STATE OF UTAH DEPARTMENT OF NATURAL RESOURCES DIVISION OF OIL, GAS AND MINING						FORM 3 AMENDED REPORT				
<b>APPLICATION FOR PERMIT TO DRILL</b>						1. WELL NAME and NUMBER Parkinson 14-15-3-2W

**Newfield Production Company**  
**Parkinson 14-15-3-2W**  
**SE/SW Section 15, T3S, R2W**  
**Duchesne County, UT**

# **ON-SITE PREDRILL EVALUATION**

# Application for Permit to Drill Statement of Basis

**NEWFIELD EXPLORATION COMPANY****PROPOSED LOCATION LAYOUT****14-15-3-2W***Pad Location: SESW Section 15, T3S, R2W, U.S.B.&M.***Note:**

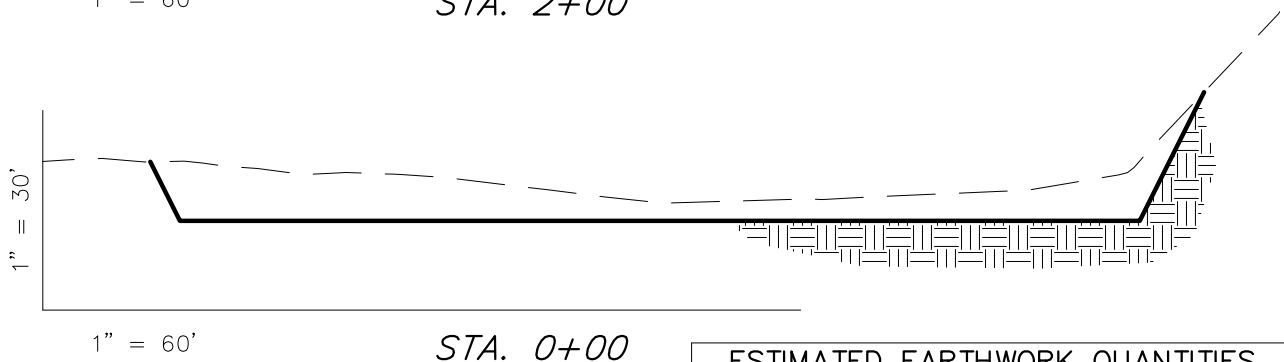
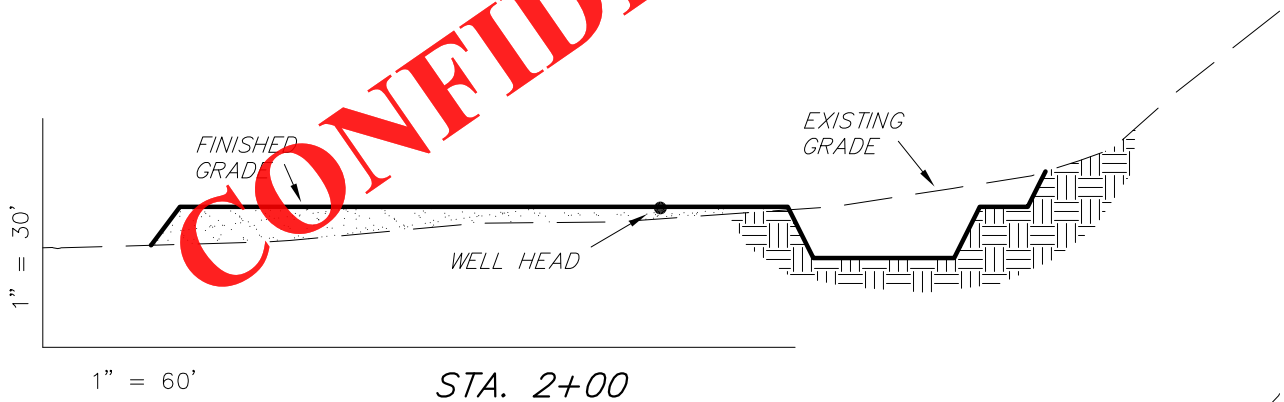
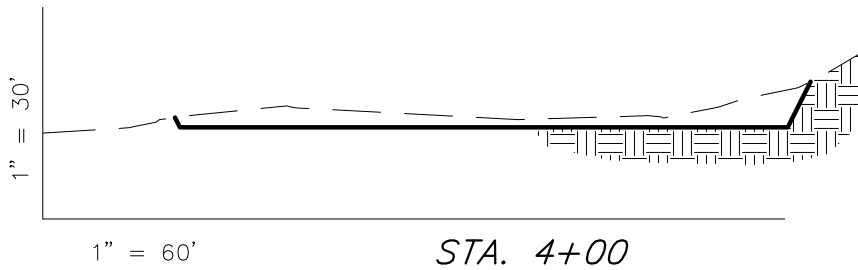
Northern corner will be cut off to avoid disturbance to butte.

water to be diverted around pad on all sides except the south. Rilling present on north slopes and will need to be directed to diversion

steep slopes on the north will need to be protected from erosion and water directed around pad

Pit to be dug to a depth of 8'. Because of the likely hood of disturbance to existing sandstone bedrock and clastic basalt observed on the surface, pit underlayment is to be used to protect the liner from potential puncture. Pit should be fenced to prevent entry by deer, other wildlife and domestic animals. Pit to be closed within one year after drilling activities are complete.

<b>Category</b>	<b>Condition</b>
Pits	A synthetic liner with a minimum thickness of 16 mils with a felt subliner shall be properly installed and maintained in the reserve pit.
Surface	The reserve pit shall be fenced upon completion of drilling operations.
Surface	Drainages adjacent to the proposed pad shall be diverted around the location.
Surface	The well site shall be bermed to prevent fluids from leaving the pad.
